MILITARY
SPECIFICATION

MIL-C-10405A(SigC)
Amendment No. 3
29 July 1959
Superseding
Amendment No. 2
4 March 1958

CRYSTAL UNITS, QUARTZ, PRESSURE
AND SPACER MOUNTED

FIGURE 4.

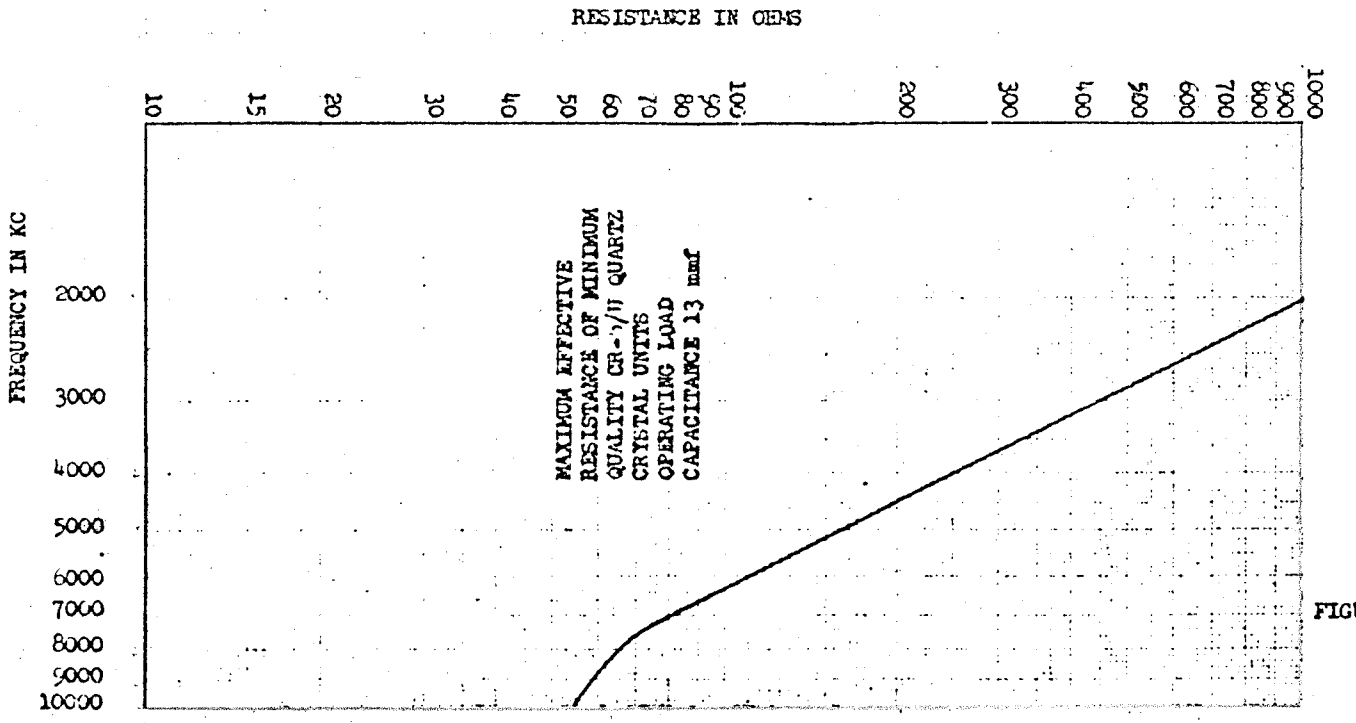
16. Figure 4: Replace present Figure 4 with revised Figure 4 as shown on page 3 of this Amendment.
